Approved with notes

Job T22-08009P	Truss T01	Truss Type FINK	Qty 13	Ply 1	CHRIS McNEILL	153436336
-------------------	--------------	--------------------	-----------	----------	---------------	-----------

Floor Plan of Addition

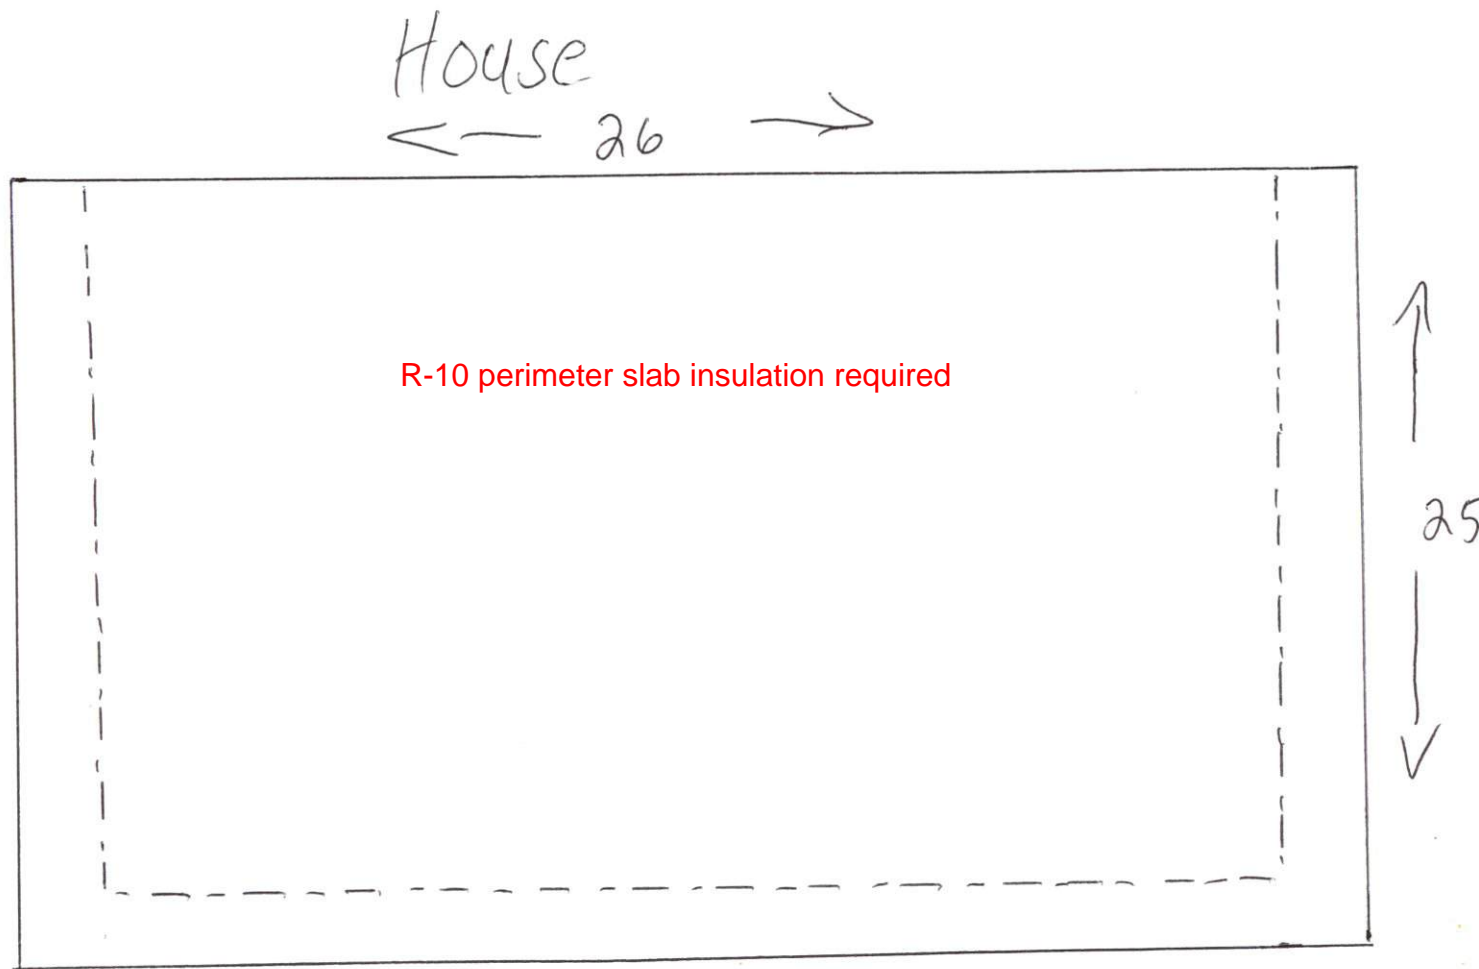
4" of Screening

4" of concrete 3000 psi with fiber

Footer 1ft wide 1ft deep

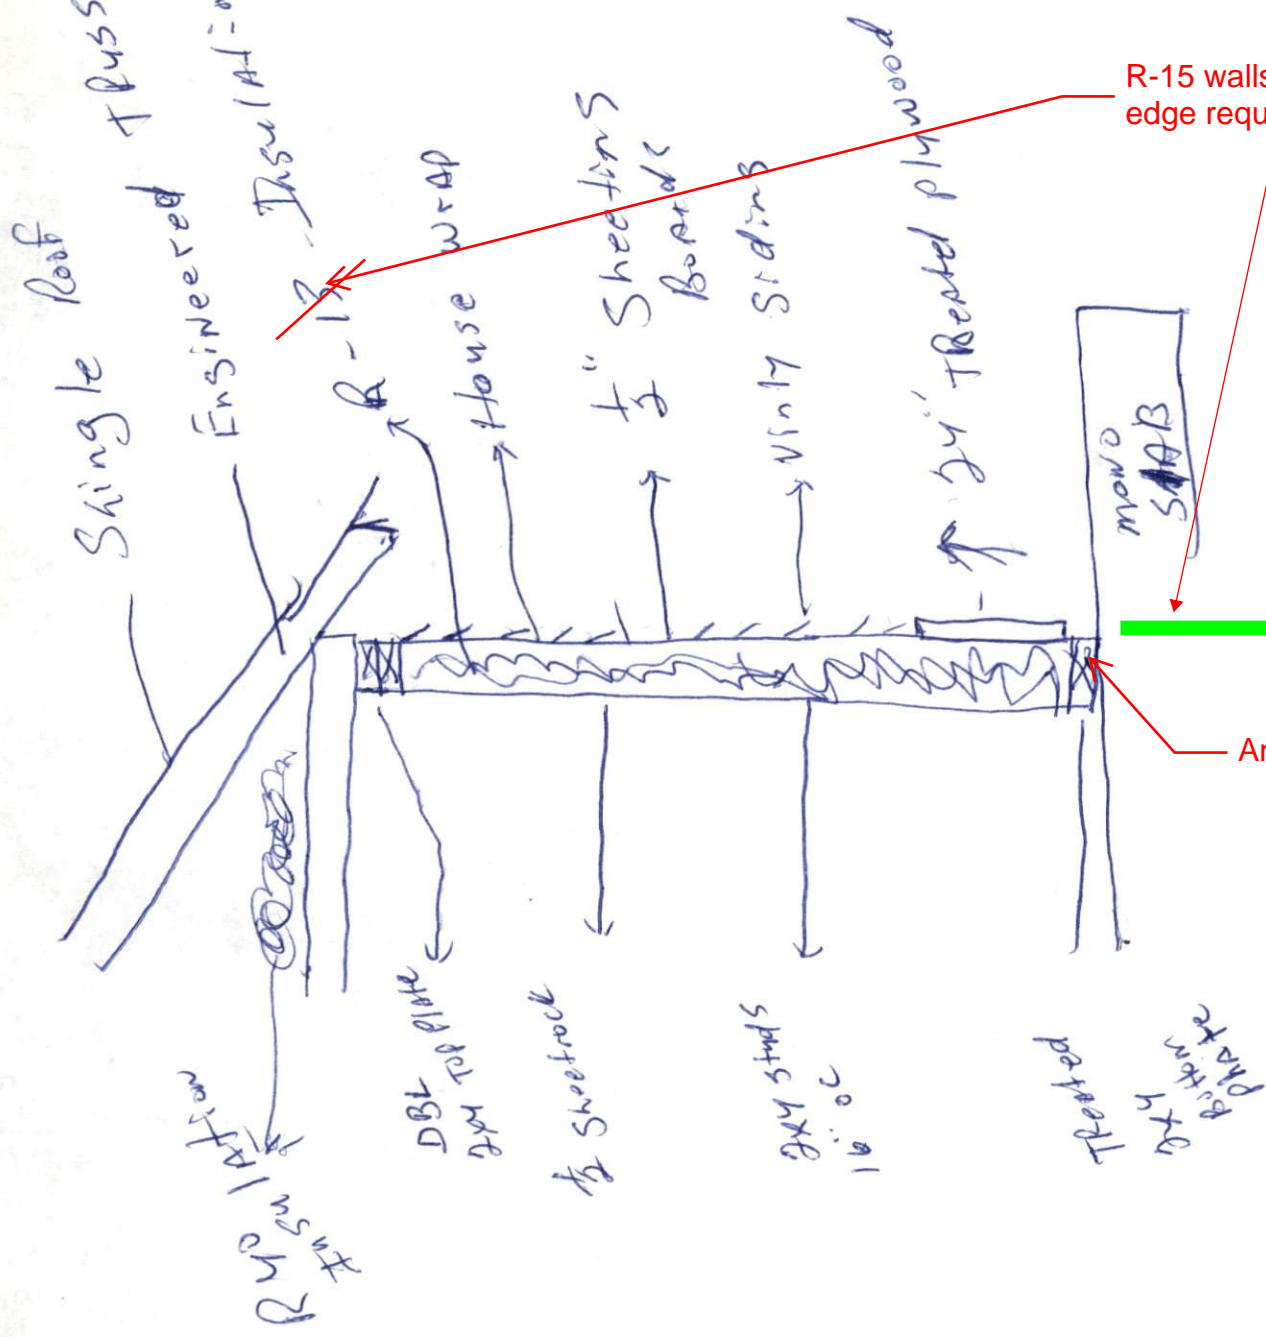
Shingle Roof
Truss 24" o.c

Engineered
Insulation

R-15 walls. R-10 slab edge required

Anchor bolts per code
